Job Title
CNG HINKLEY WATLING STREET

Drawing Title
DMRB REVIEW OF SWEEP PATH ANALYSIS OF SITE ACCESS OFF WATLING STREET - 16.5m ARTIC

**CNG FUELLING FACILITY, WATLING
STREET, HINCKLEY, LE10 3ED**

TRANSPORT STATEMENT ADDENDUM

Scale	AS SHOWN	Date	SEPT 23	Designed	BEB
Drawn	BEB	Checked	MJB	Approved	MJB
Job No	22-240	Drawing No	22-240-007	Rev	H

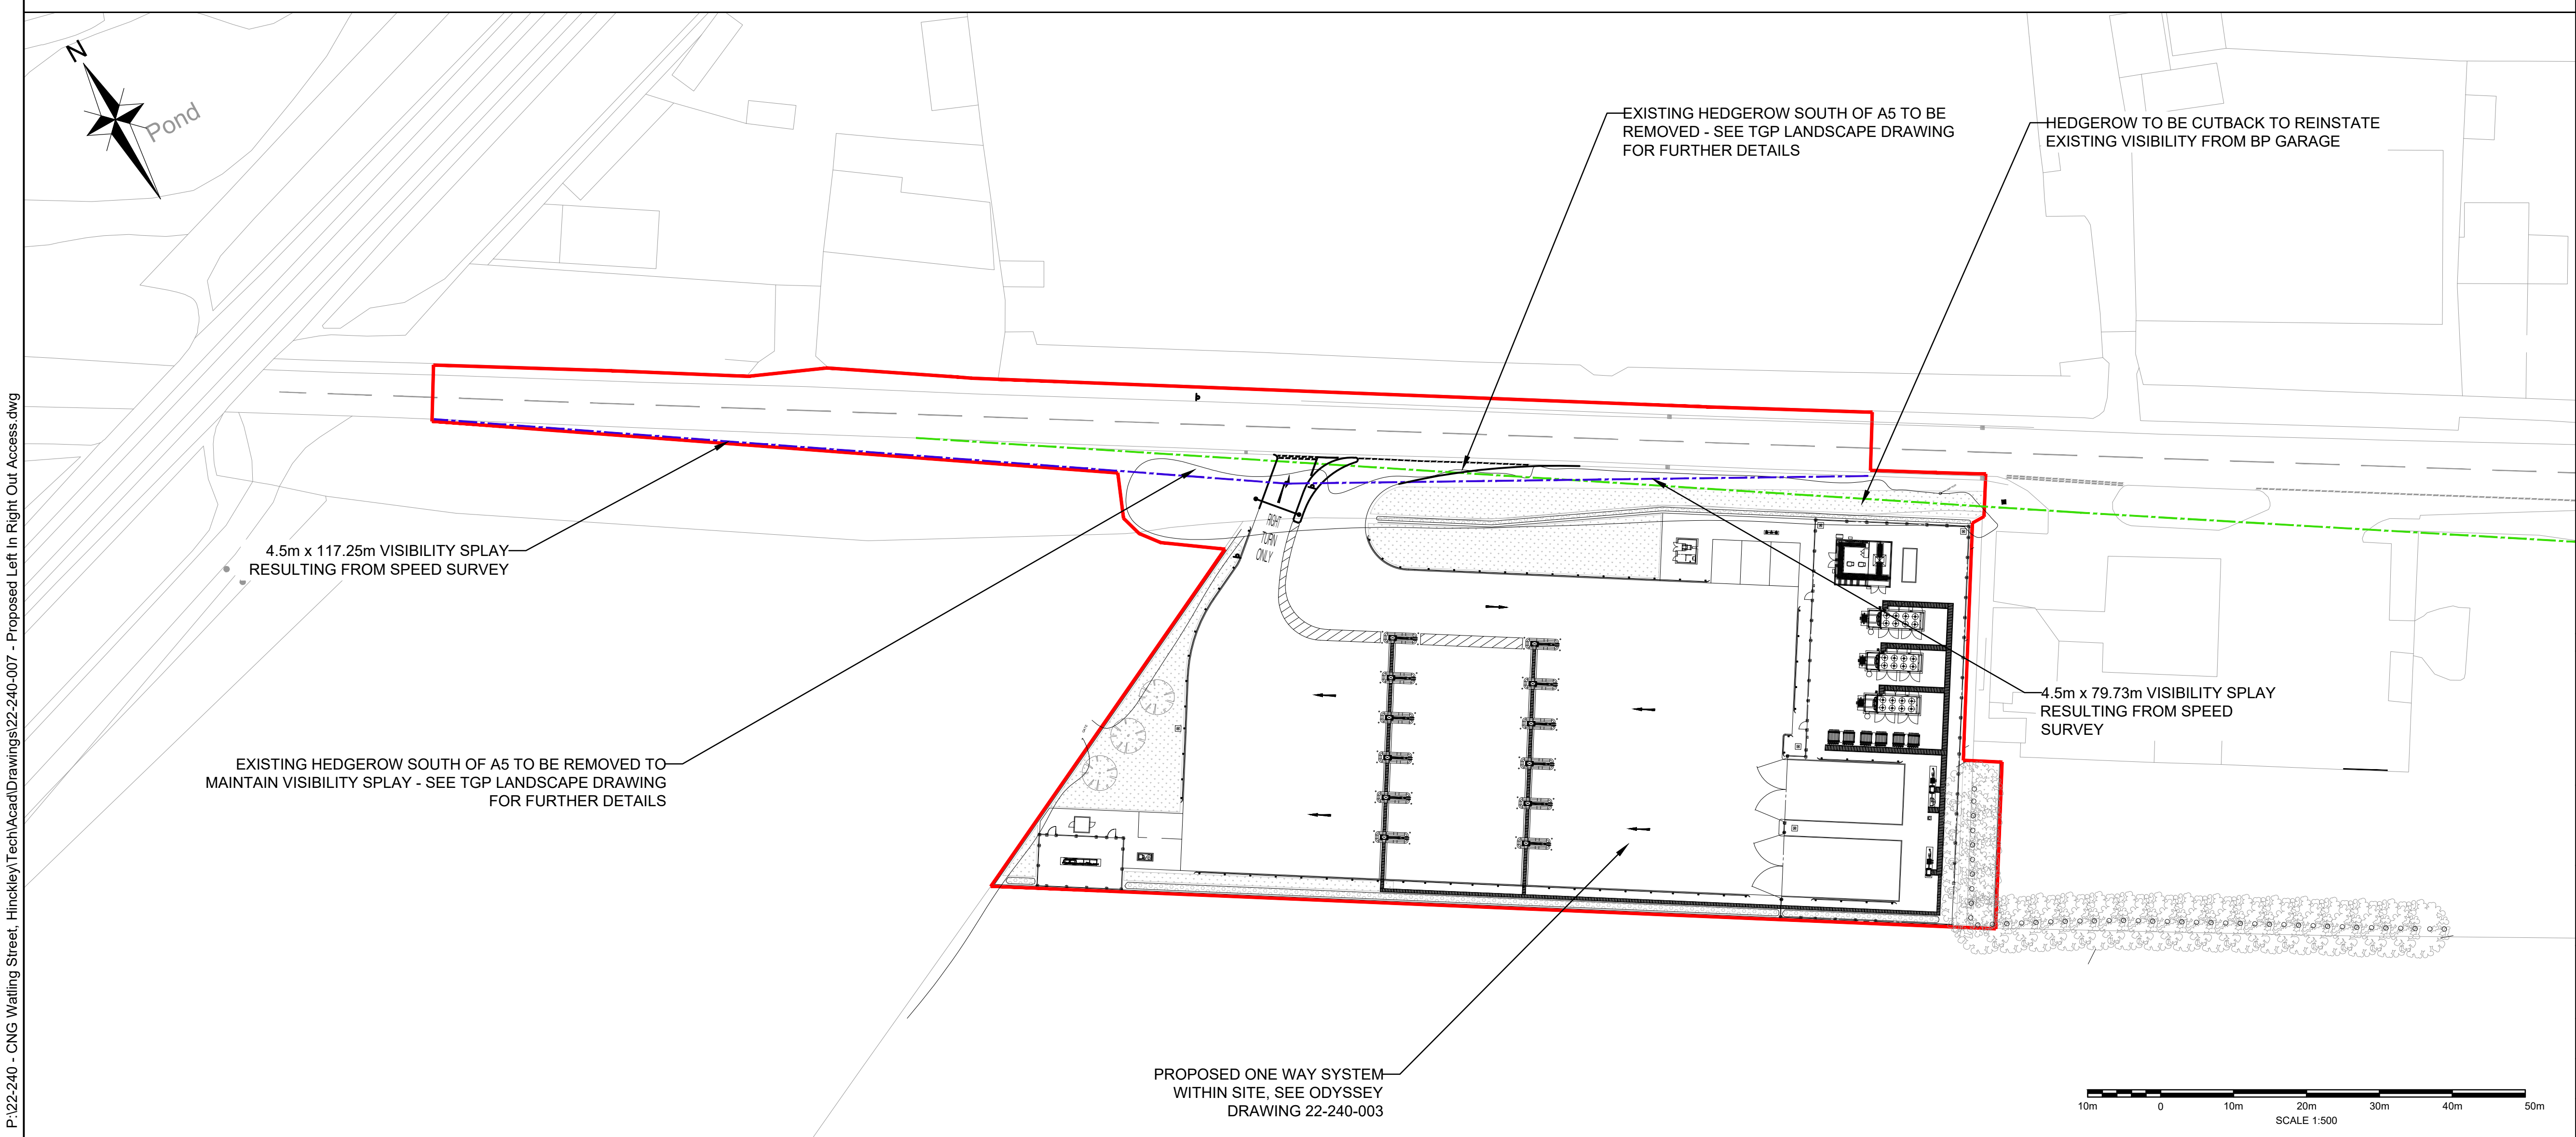
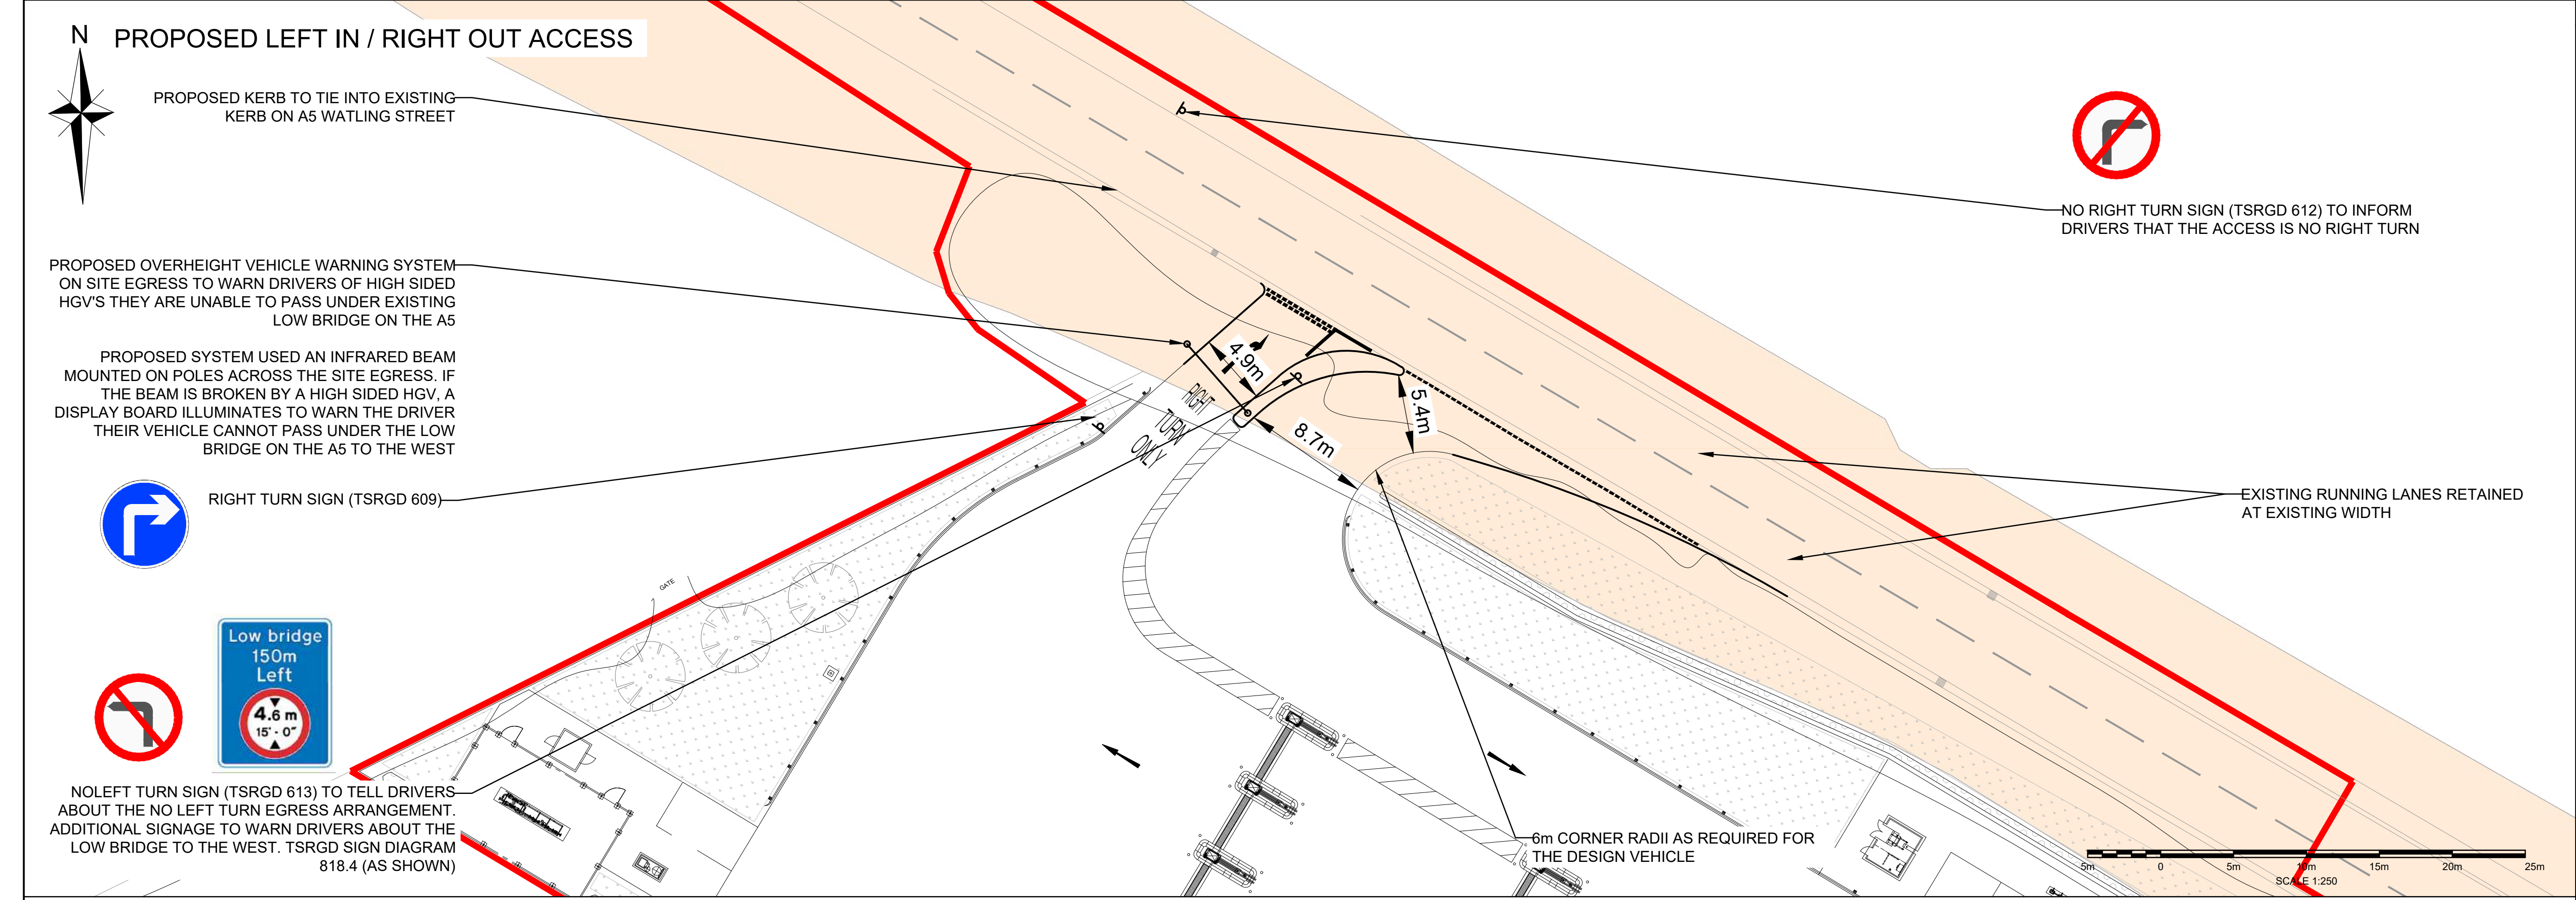
The proposals which are demonstrated on Drawing 22-240-001 include for a ghost island right-turn lane arrangements for eastbound vehicles and would allow through traffic on the A5 to be unimpeded by vehicles which would associated with the development.

Visibility splays of 4.5m by 160m are achievable from the proposed access in either direction. The LHA note that visibility splays have been based on the speed limit (50 mph) and not from recorded 85th percentile speeds obtained from a speed survey. The LHA also note that the proposed access impedes the visibility splay from the BP petrol station to the east which would be unacceptable from a highway safety perspective. This issue has also been highlighted in NH's most recent consultation response dated 19th July 2023.

The Applicant previously proposed a ghost island right turn lane on the A5 to provide all movements access into the site to which the LHA and NH had significant concerns due to highway safety. The access has now been revised due to the location of the low bridge on the A5 Watling Street. The revised access now proposes a left in / right out only arrangement as demonstrated on Drawings 22-240-007C and 22-240-008C. It is understood that the access has been designed to prohibit vehicles from turning right into the site from the A5 via the use of a curved central island, which would physically prevent HGVs from making a right turn. The access would prohibit vehicles from egressing the site left onto the A5 as there would be no kerb radii to allow for this.

The LHA note that the revised access arrangements appear to be a betterment of the previously proposed access. Notwithstanding this, a Stage 1 Road Safety Audit should be undertaken and accompanied by a Designer's Response for the site access to be demonstrated to be safe and suitable.

2.2.2 Based on the comments received from LCC and NH Officers during the pre-application meeting, a revised access solution has been developed. The revised access proposes a left in, right out only arrangement (see attached **Drawings 22-240-007** and **22-240-008**). The revised access arrangement has been designed to prohibit vehicles from turning right into the site from the A5 via the use of a curved central island within the access road, which would physically prevent HGV's from making a right turn onto Watling Street.

2.2.3 The proposed access arrangements presented in **Drawing 22-240-007** would also prohibit and physically prevent vehicles from egressing left out of the site onto the A5 as there would be no kerb radii to allow for this. Instead, a small bullnose kerb with HGV bollard and/ or trief kerb would be provided where the proposed access ties into the A5. All vehicles egressing the site would instead be routed southeast towards the Hammond's Way roundabout, directly away from the A5 railway bridge.

2.3.4 The visibility splays are shown on the revised access **Drawing 22-240-007**. As shown on the drawing, the visibility splays do not extend beneath the railway bridge to the west and nor does the splay extend across the existing BP access to the east.
